Customer : CU-DAR001 Dart Helicopters Services	Drawing Name : PANEL-350 FWD CANOPY
Job Number : 39498	
Estimate Number : 13099	
P.O. Number :	Part Number : D36563
This Issue : 5/26/2008 S.O. No. :	Drawing Number : D3656 REV A
Prsht Rev. : NC	Project Number : 00204
First Issue : / / Type : THERMOFORMING	Drawing Revision : A
Previous Run : 38506	Material :
Written By :	Due Date : 5/30/2008 Qty: 4 Um: Each
Checked & Approved By : <u>JND 08.5.26</u>	
Comment : Est. Rev. A 07/12/13 DL verified by:DD

**D3656-3 PANEL**

**From:** David Shepherd [dshepherd@dartaero.com]  
**Sent:** Wednesday, June 18, 2008 3:30 PM  
**To:** 'Peter Hum'  
**Cc:** 'Bill Beckett'; 'Mike Petsche'; 'Daryl Leger'  
**Subject:** RE: Deviation for permanent change on D3656-3 Ceiling Panel - D350-766

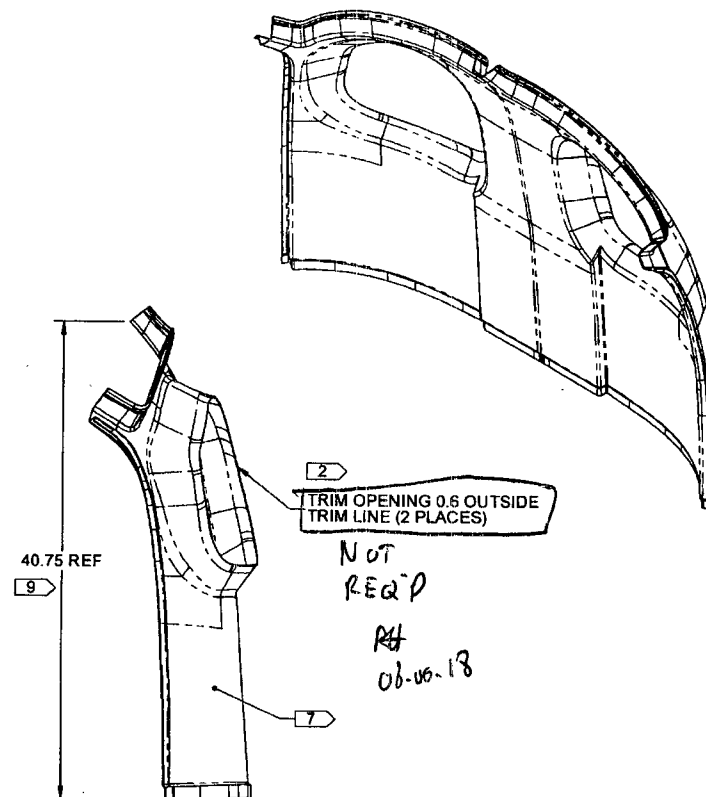
W/O:		WORK ORDER CHANGES					
DATE	STEP	PROCEDURE CHANGE	By	Date	Qty	Approval Chief Eng / Prod Mgr	Approval QC Inspector
08.06.19	7	TRIMMING OF D3655-3 (see DWG D3655 PG 2 ZONE C-2) for ceiling window not required.  PERMANENT CHANGE	PH	08.06.19	ALL (46)	PH 08.06.19 Q35 042 (SEE ATTACHED)

Production is making the D3656-3 Ceiling Panel for the D350-766 interiors. Per the drawing, the openings for the aircraft ceiling windows (i.e. skylights) are to be trimmed here @ Dart. See attached drawing (Zone C2).

Production has been determined that the trimming of the openings is time-consuming. In speaking with Daryl, even if we trimmed the openings per the drawing the customer might still need to trim the opening even more to fit his roof (this is based on the fit that was done on the A-Star we have here). It should be noted, that we haven't tried this install or received any feedback from a customer in the field that has installed these.

- a) The customer/installer would have to trim the entire opening from scratch. The Installation Instructions only indicates that this panel be centered on the aircraft ceiling windows (see attached excerpt). There is no indication that this area needs to be trimmed by the customer.

Therefore, is it acceptable to NOT trim the openings?

OK with me. Update dwg and IIN accordingly.
